Access Compliance Report

Public Rights-of-Way

(Curb Ramps)

Intersection ID: 13959	Main Street: CLEVELAND_AV	Cross Street: E_PARK_AV	Location: W
ADA ID: 0862DBA46E7E	Ramp Type: Perp	Initial Pass/Fail: Fail	Overall Compliance: No
Severity Score: 13.75			
Codes/Mitigation Info/Possible Solution		Field Measurements/Component Compliance

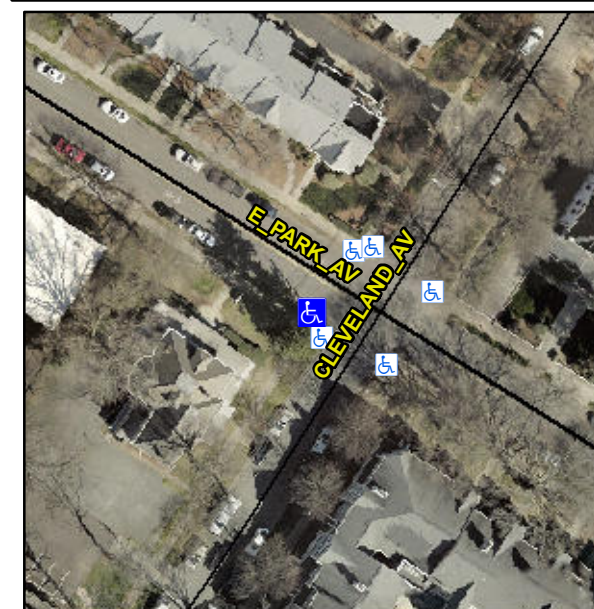
Not Found, R304.2.2, R304.5.3

Compliance	Description	Data	Compliance	Description	Data
N/A	Ramp Length (in)	38.0	No	Ramp Slope (%)	8.9
Yes	Ramp Width (in)	110.0	No	Ramp XSlope (%)	3.2
N/A	Flare Type LT	N/A	N/A	Flare Type RT	N/A
N/A	Flare Slope LT (%)	N/A	N/A	Flare Slope RT (%)	N/A
N/A	Flare Traversable LT?	N/A	N/A	Flare Traversable RT?	N/A
N/A	Landing Length (in)	N/A	N/A	DWS Provided?	N/A
N/A	Landing Width (in)	N/A	N/A	DWS Contrast?	N/A
N/A	Landing Slope (%)	N/A	N/A	DWS Length (in)	N/A
N/A	Landing X Slope (%)	N/A	N/A	DWS Full Width?	N/A
N/A	Landing Curb? (Y/N)	N/A	N/A	DWS Offset (in)	N/A
N/A	Shared Landing?	N/A			
N/A	Gutter Ponding?	N/A	N/A	Gutter Slope (%)	N/A
N/A	Gutter Lip Ht (in)	N/A	N/A	Gutter X Slope (%)	N/A
N/A	Painted X Walk1?	No	N/A	Painted X Walk2?	N/A
	X Walk 1 Direction	To NE		X Walk 2 Direction	N/A
N/A	X Walk 1 Width (in)	N/A	N/A	X Walk 2 Width (in)	N/A
	X Walk 1 Slope (%)	4.8		X Walk 2 Slope (%)	N/A
	X Walk 1 X Slope (%)	0.9		X Walk 2 X Slope (%)	N/A

Remove & Replace Entire Ramp.
